Planning Application: S/RES/25/1389
Reserved Matters – Parcels R1–R2, New Eastern Villages

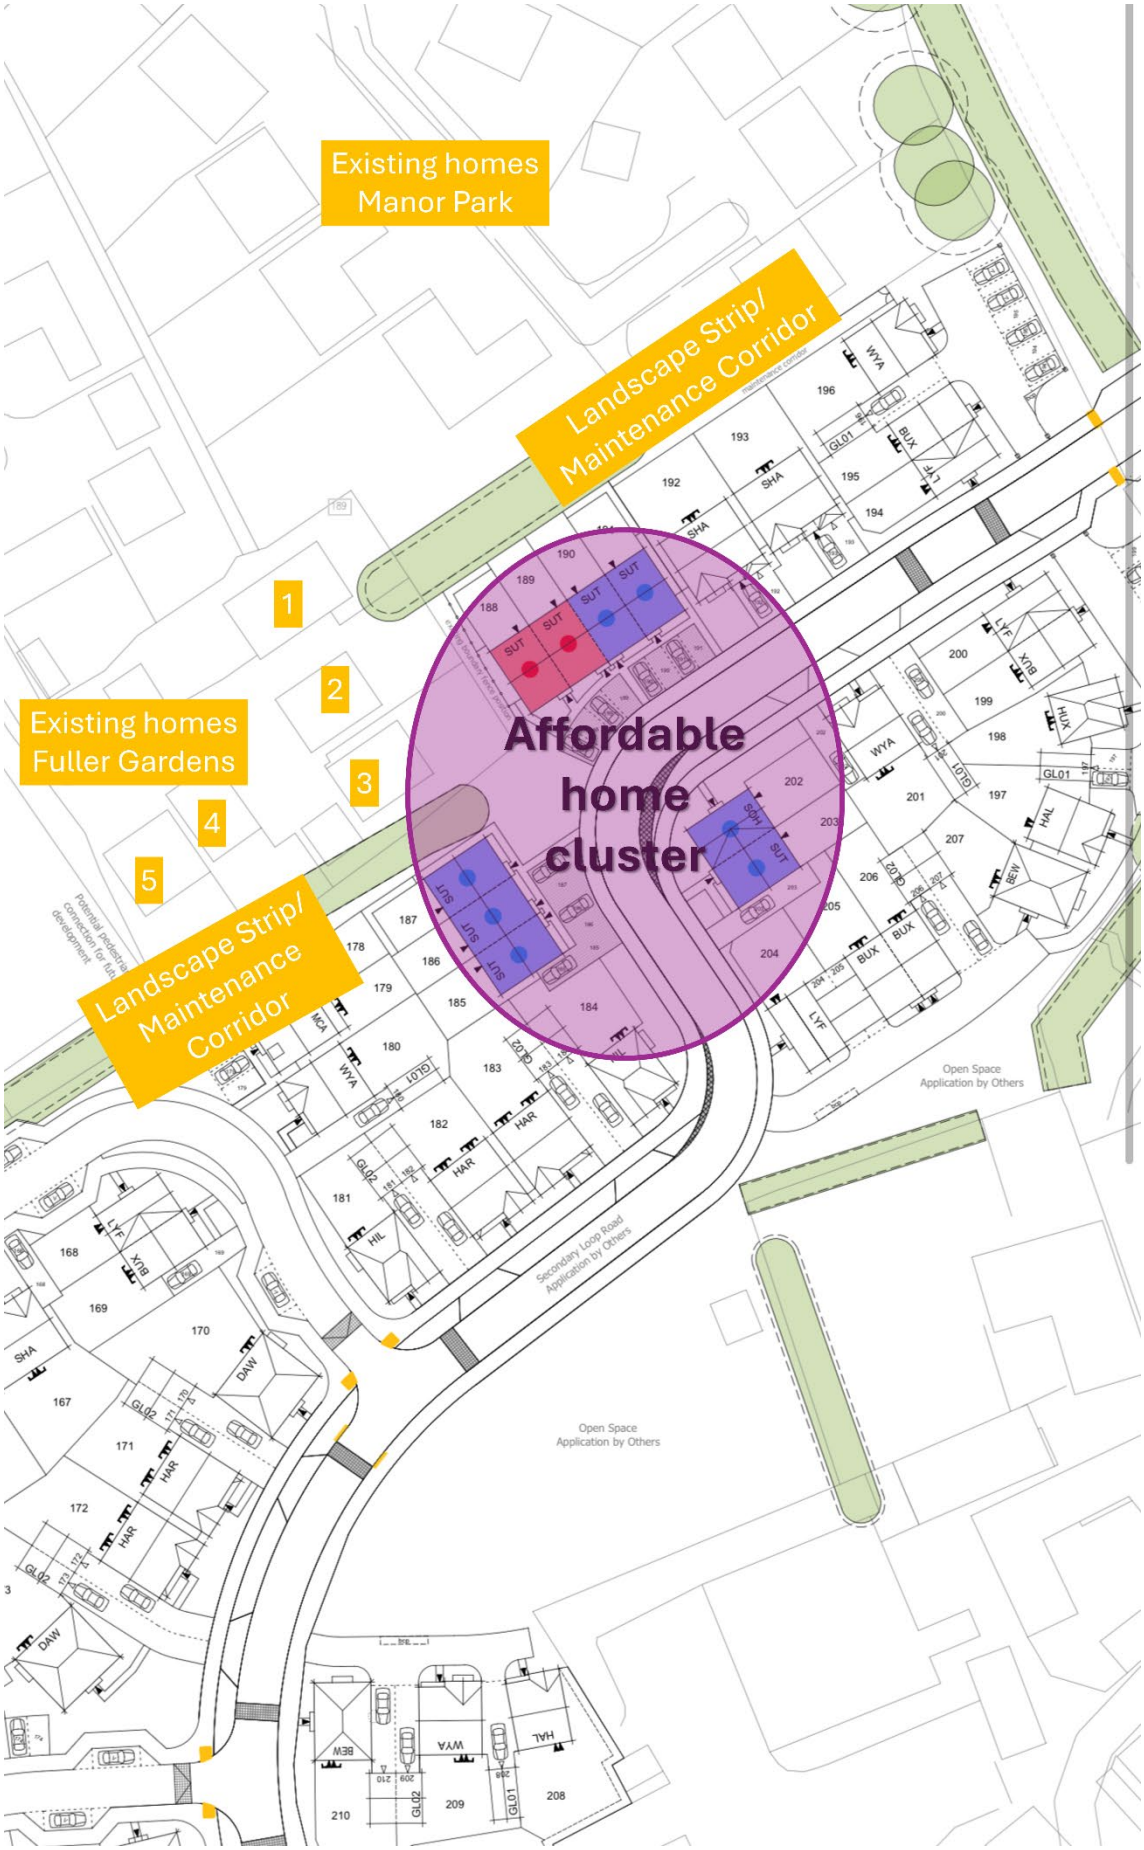
Having reviewed the Affordable Housing Layout submitted with the application, it appears that a notable proportion of the shared ownership and affordable rent dwellings are located in the area immediately adjacent to the northern boundary near my property.

Based on the submitted drawings, approximately 24 affordable units appear to be proposed across the development. Of these, approximately nine units appear to be located in close proximity to the boundary with existing homes on Fuller Gardens and Manor Park **(Ref Pg 4)**.

Given that this part of the site forms the development edge where the new scheme meets the existing residential area, I would be grateful if the Local Planning Authority could confirm whether the distribution of affordable housing within the scheme accords with the design principles for integrated and tenure-blind communities established through the New Eastern Villages design codes.
